MIL-M-28787/38B
AMENDMENT 2
31 December 1992
SUPERSEDING
AMENDMENT 1
28 December 1982

MODULES, STANDARD ELECTRONIC

RELAY, DPDT, POWER, KEY CODE NPM

FIGURE 5. Open contact resistance test circuit for table III.

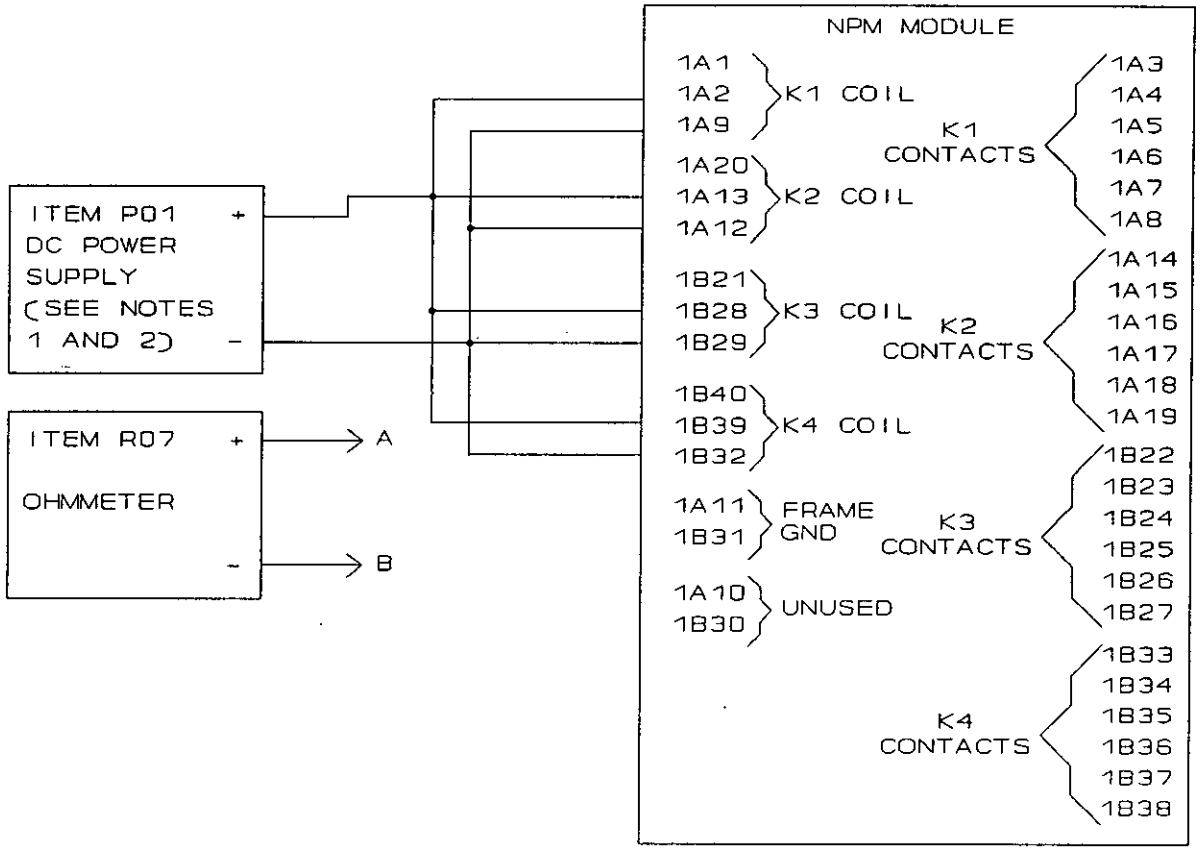
FIGURE 5: Delete and substitute new figure 5 as printed on page 3 of this amendment.

NOTES:
1. For measurement of test conditions B1-B8, item P01 shall be adjusted to 0.8 ± 0.1 Vdc.
2. For measurement of test conditions B9-B16, item P01 shall be adjusted to 4.5 ± 0.1 Vdc.

FIGURE 9. Pick-up and drop-out voltage test circuit for tables IX and X.

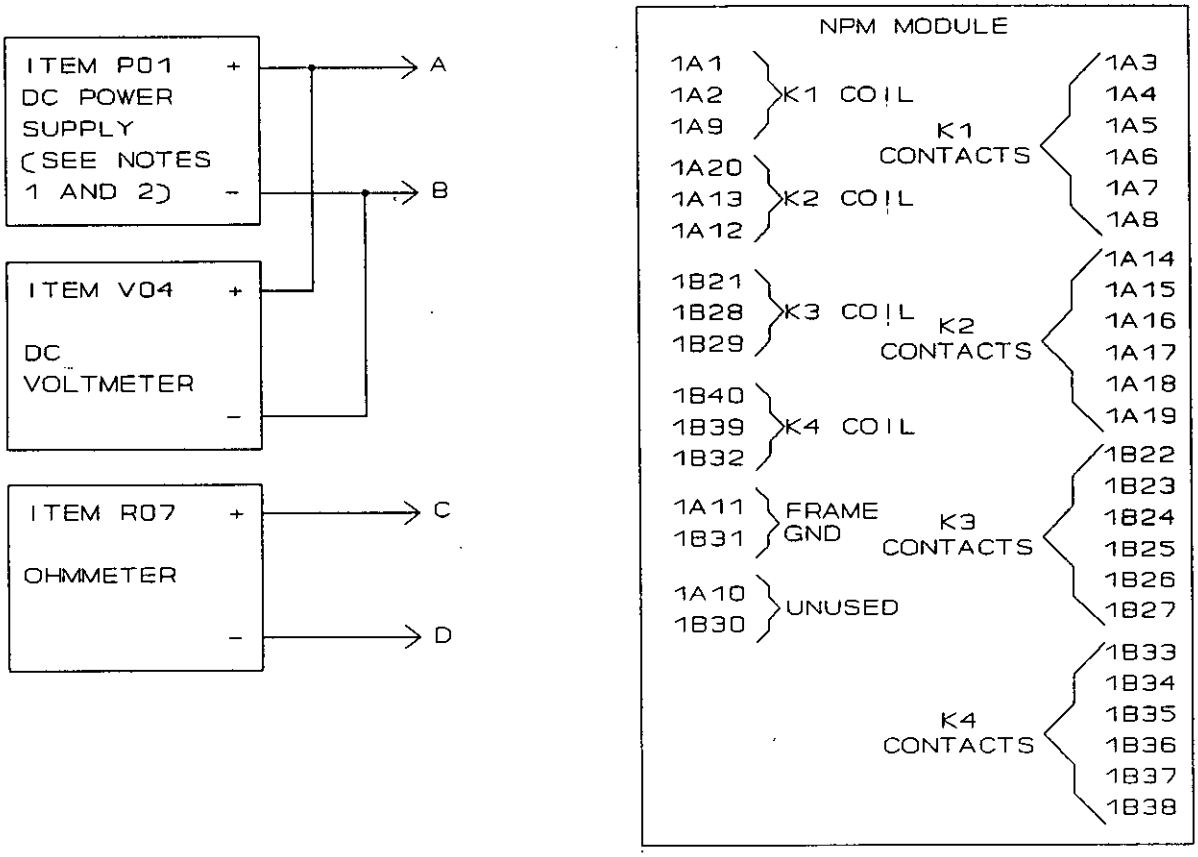
*FIGURE 9: Delete and substitute new figure 9 as printed on pages 4 and 5 of this amendment.

1. Test procedure for test conditions H1-H8:
   (a) Connect test points A, B, C, and D as specified for test condition H1.
   (b) Adjust output of item P01 for 8.0 Vdc ± 5% as measured on item V04. Maintain this voltage for a period of 1 to 3 seconds.
   (c) Gradually reduce the output voltage of item P01 to zero. The contact resistance, as measured on item R07, should be 1 megohm or greater.
   (d) Gradually increase the output voltage of item P01 until the contact resistance, as measured on item R07, drops to 1 ohm or less.
   (e) The pick-up voltage shall be read on item V04, and shall be as specified for test condition H1.
   (f) Repeat notes (a) through (e) for test conditions H2-H8.

2. Test procedure for test conditions J1-J8:
   (a) Connect test points A, B, C, and D as specified for test condition J1.
   (b) Adjust output of item P01 for 8.0 Vdc ± 5% as measured on item V04. The contact resistance, as measured on item R07, should be 1 megohm or greater.
   (c) Gradually reduce the output voltage of item P01 until the contact resistance, as measured on item R07, drops to 1 ohm or less.
   (d) The drop-out voltage shall be read on item V04, and shall be as specified for test condition J1.
   (e) Repeat notes (a) through (d) for test conditions J2-J8.
